Comal County Environmental Health OSSF Inspection Sheet

Permit#: 110267 Address: 2046 HORNSBY

Permit of Authorization to Construct an On-Site Sewage Facility Permit Valid For One Year From Date Issued

AEROBIC TREATMENT DRIP TUBING SYSTEM
DESIGNED FOR: FERNANDO ROJO & ANGELITA ROJO
SITE ADDRESS: 2046 HORNSBY DRIVE CYPRESS COVE, LOT 355 SECTION 2

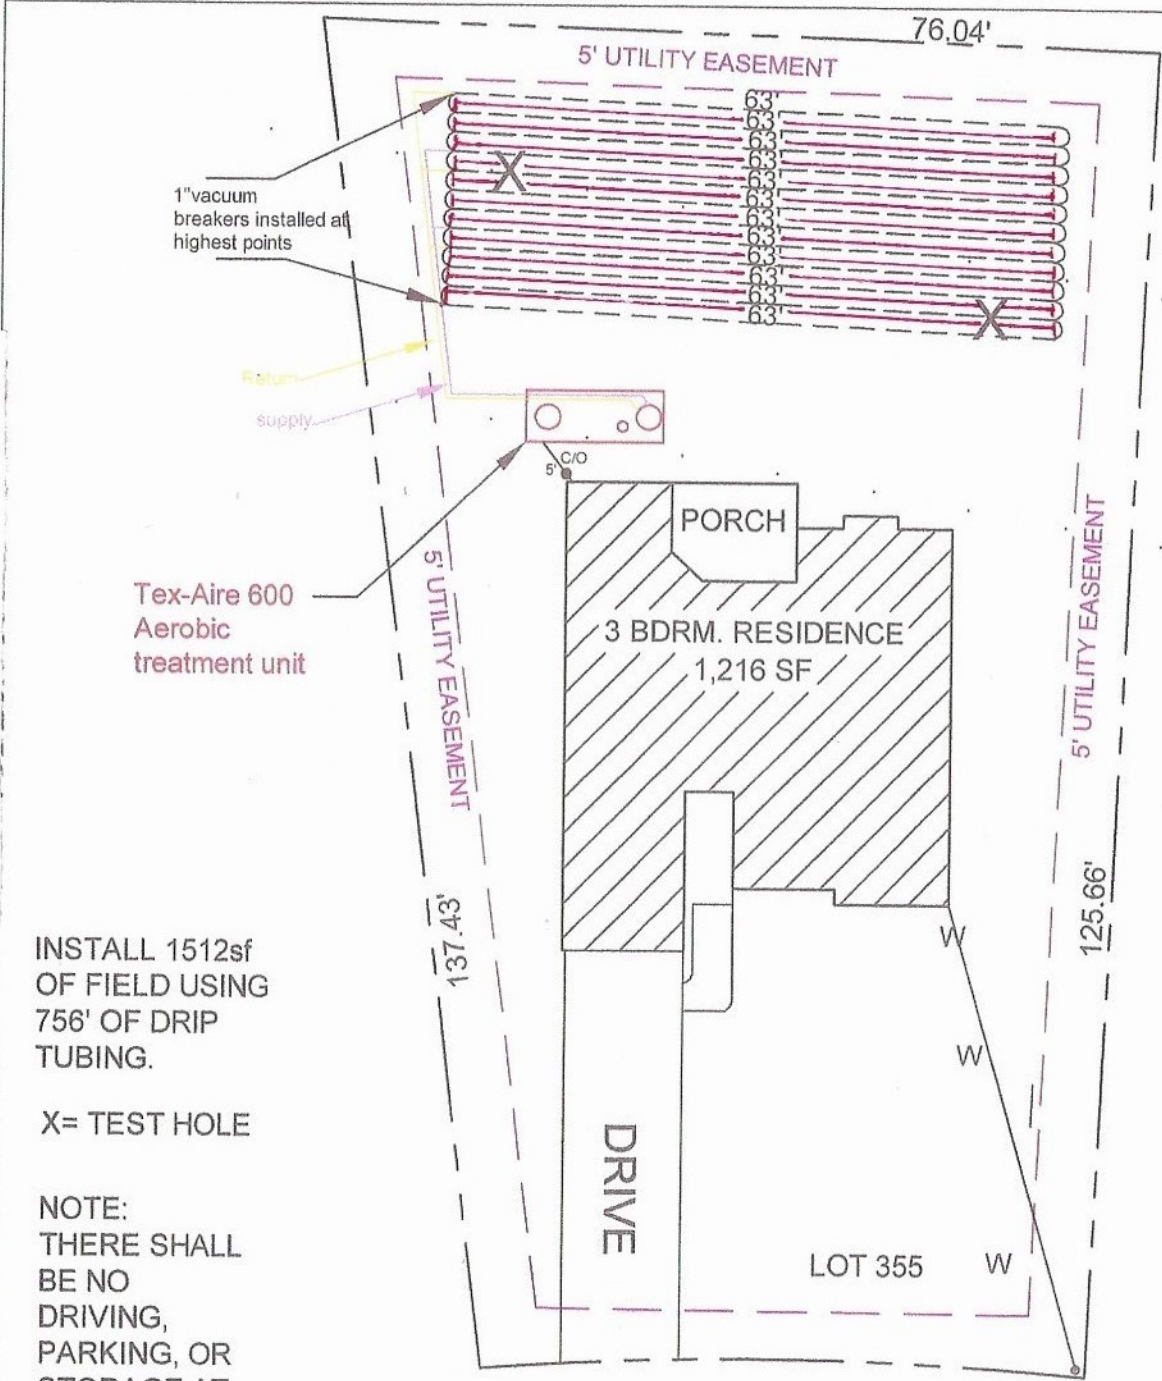
- ✓ 1. Dimension each drip line on the design.
- ✗ 2. Verify that there will be a minimum of 12 inches of suitable soil under the drip tubing located over the tank/ATU.
- ✓ 3. The amount of absorption area on the 2nd page of the permit application must be updated to match the revised area.
- ✓ 4. The remaining planning materials must be revised as needed to match the latest revised design.
- ✓ 5. The pump tank detail must be revised to include the height and location of all pump tank settings, and identify the minimum reserve capacity provided.
6. Revise as needed and resubmit.

INSTALL 1512sf OF FIELD USING 756' OF DRIP TUBING.

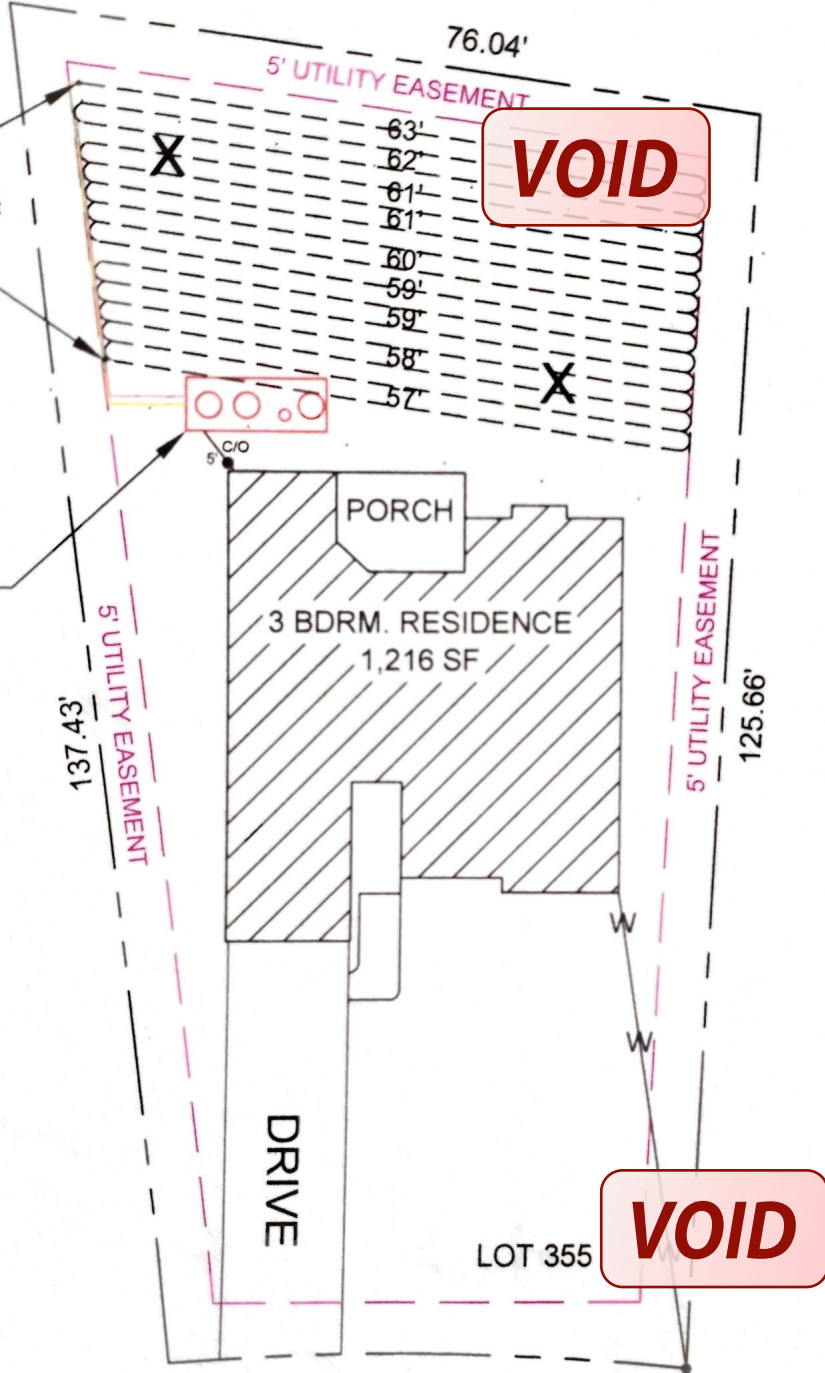
- ✓ 1. The design specifications are contradicting. It indicates 1660 sq. ft. of absorption area is required, but the next line indicates 1200 sq. ft. required.
- ✓ 2. A minimum of 6 inches of cover is required over the drip tubing.
3. Revise as needed and resubmit.

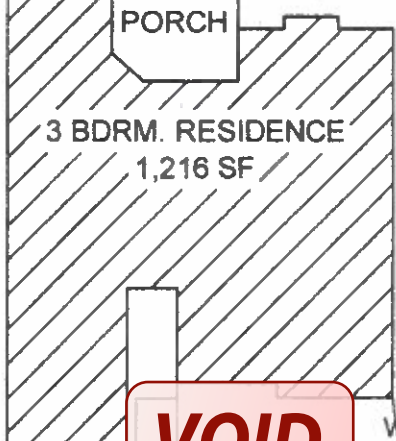
1. A minimum of 12 inches of soil is required below the drip tubing over the tank/ATU.
2. Revise planning materials accordingly and resubmit.

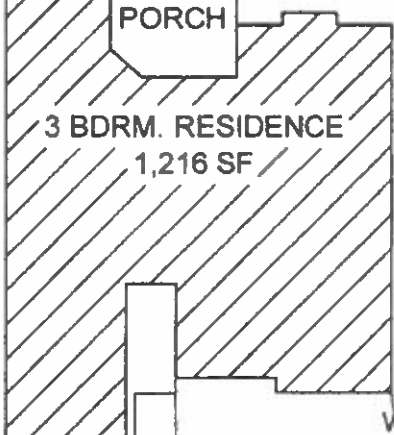
- ✓. Add the subdivision section number to the permit application.
2. With a .2 loading rate a minimum of 12 inches of soil is required below the drip lines. The planning materials call for only 8 inches of soil to be added on top of the 3 inches of existing soil, and indicate only 8 inches of soil below drip lines over the tank/ATU.
- ✓. Dimension each drip line on the design.
- ✓. Show the supply line from the tank/ATU to the drip field and the return line from the drip field to the tank/ATU.
5. Revise as needed and resubmit.
